INDESIT company

Model type:
MBM1722VFR

Commercial code:
F036363

N1030093fig1

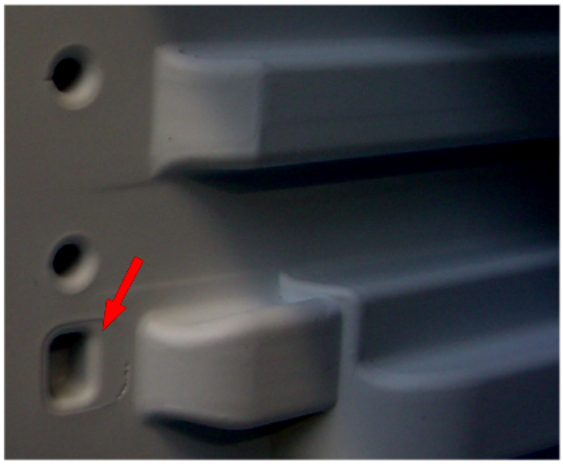
From August 05 (serial no. 50802.0001) the freezer evaporator is secured to the cabinet by a plastic profile.
The cabinet walls have been modified to create locations to house the profile, which is installed on the front of each evaporator plate (see photo N1030093fig1- fig2 - fig3)
The profile cannot be fitted on premodification appliances, so technical personnel must continue to fit the rh and lh supports on these models (see photo N1030093fig4)

New parts
C00141135 = WHITE PROFILE L=443.5 MM

Parts replaced
C00075596 = EVAPORATOR RH SUPPORT
C00075597 = EVAPORATOR LH SUPPORT

N1030093fig1

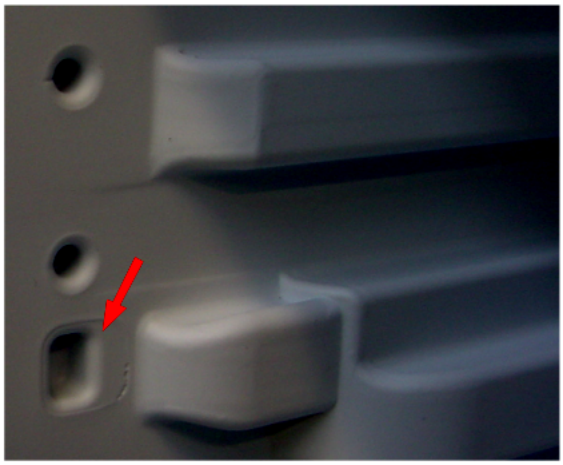
From August 05 (serial no. 50820.0001) the freezer evaporator is secured to the cabinet by a plastic profile.
The cabinet walls have been modified to create locations to house the profile, which is installed on the front of each evaporator

plate (see photo N1030093fig1- fig2 - fig3)
The profile cannot be fitted on premodification appliances, so technical personnel must continue to fit the rh and lh supports on these models (see photo N1030093fig4)

New parts
C00141135 = WHITE PROFILE L=443.5 MM

Parts replaced
C00075596 = EVAPORATOR RH SUPPORT
C00075597 = EVAPORATOR LH SUPPORT
